May 19, 2025

Blue Jay Point County Park - Renovation Wake County

ADDENDUM #6

L155

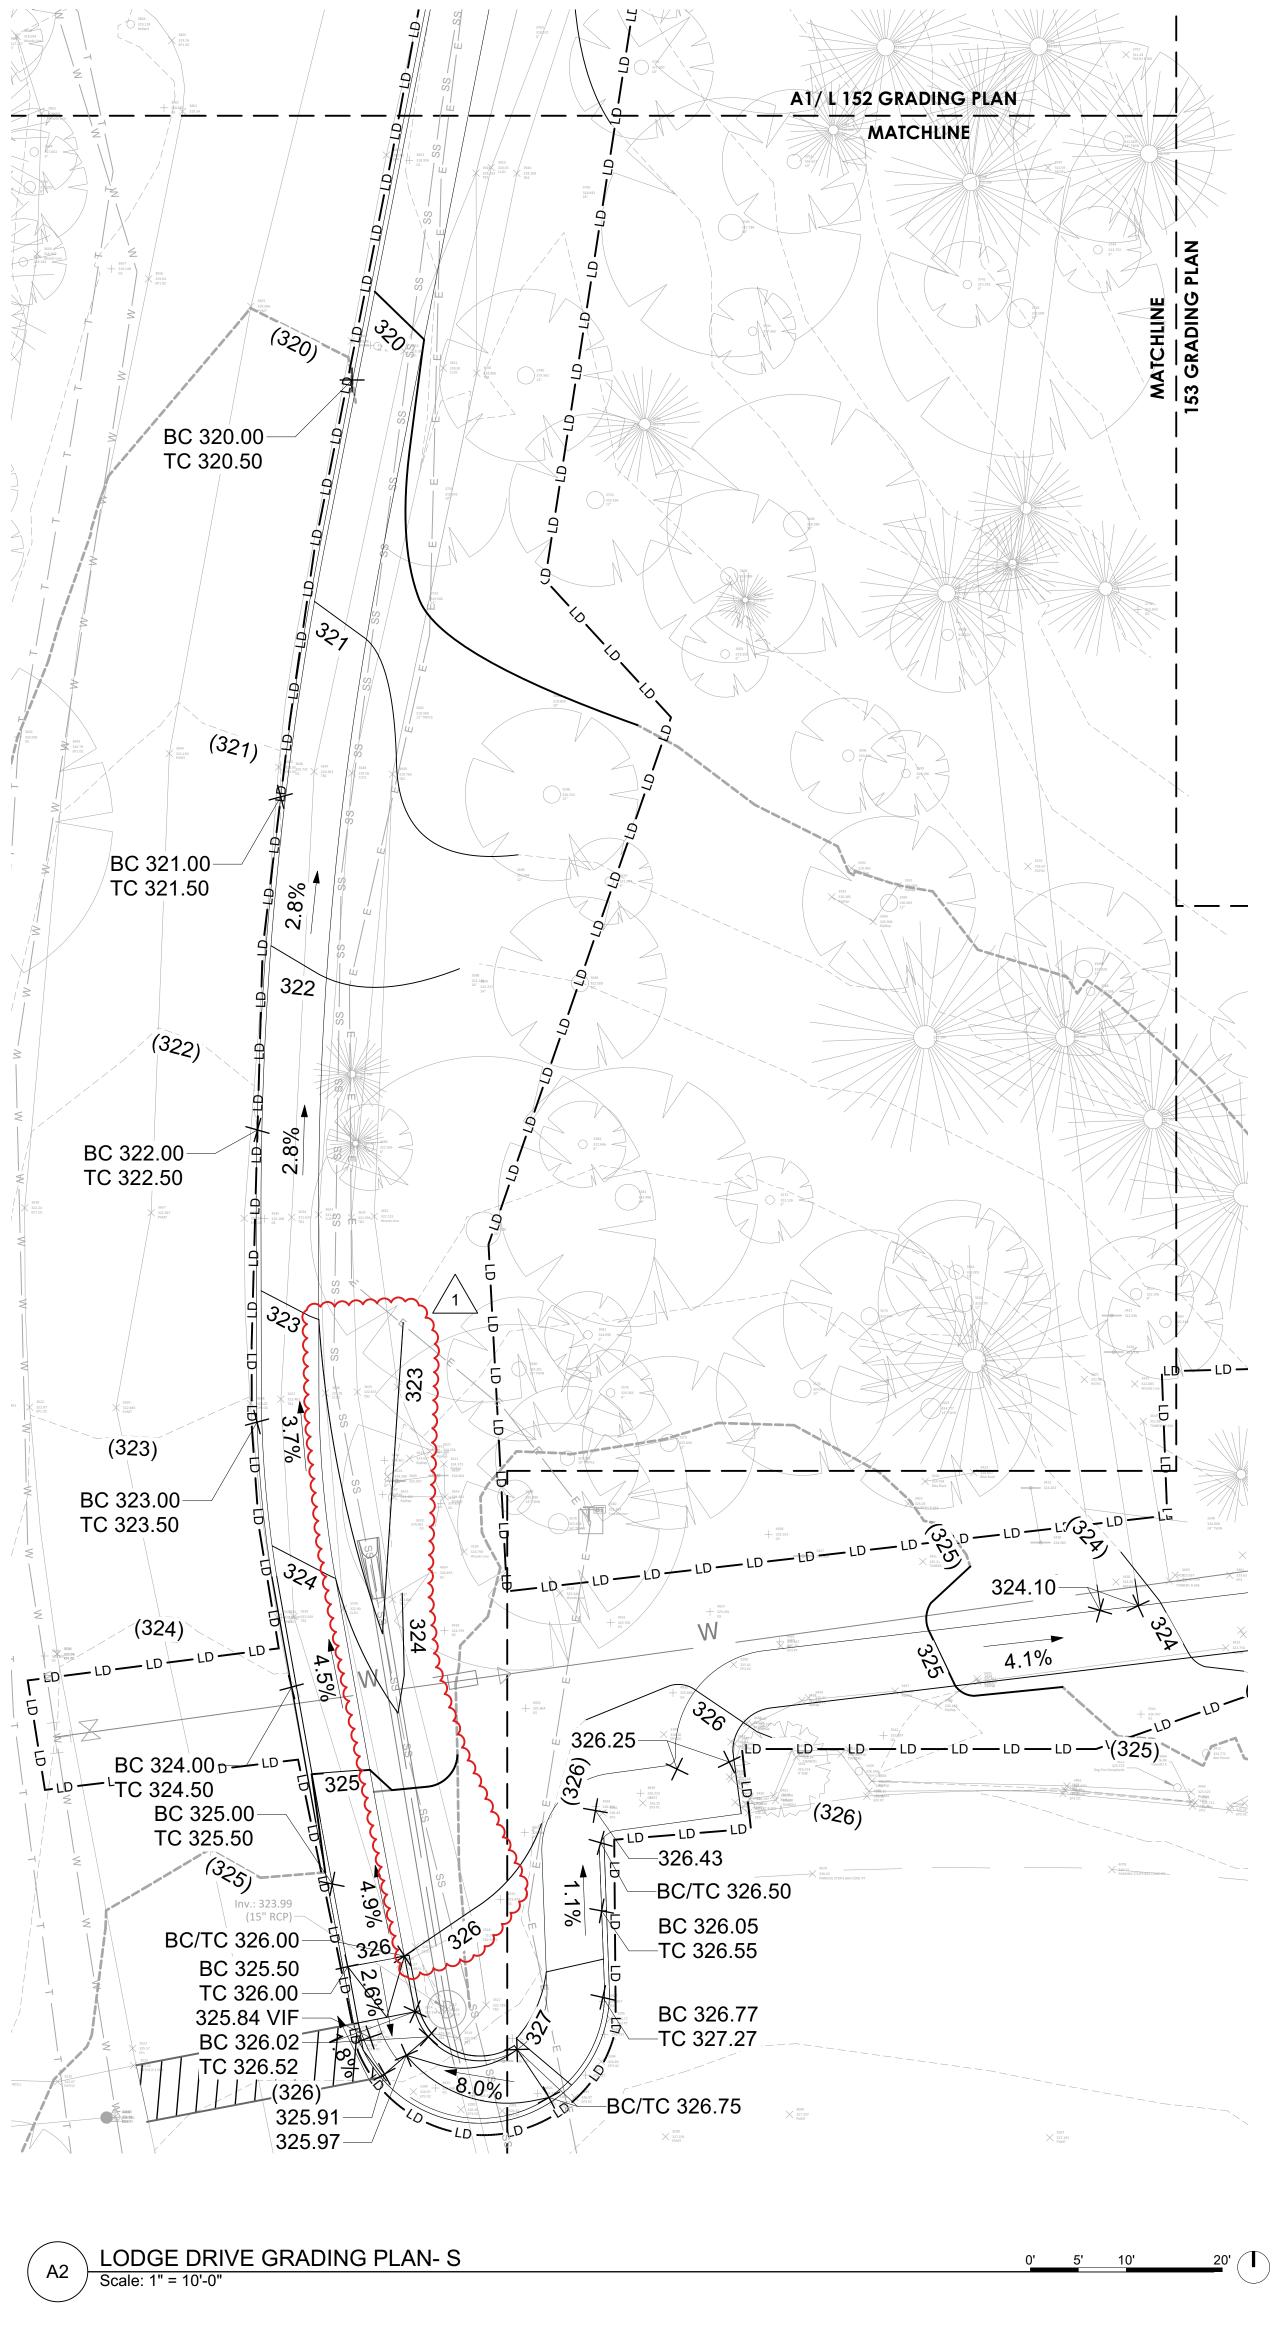
- 1. L150: Revised fine grading near park shelter
- 2. L152: Revised contours in parking lot near SCM
- 3. L155: Revised contours near trail crosswalk
- 4. L159: Revised contours going downhill along the trail
- 5. C-201: Revised contours near Visitor Center's Pond
- 6. C-204: Revised contours in parking lot near SCM
- 7. C-206: Revised contours going downhill along the trail
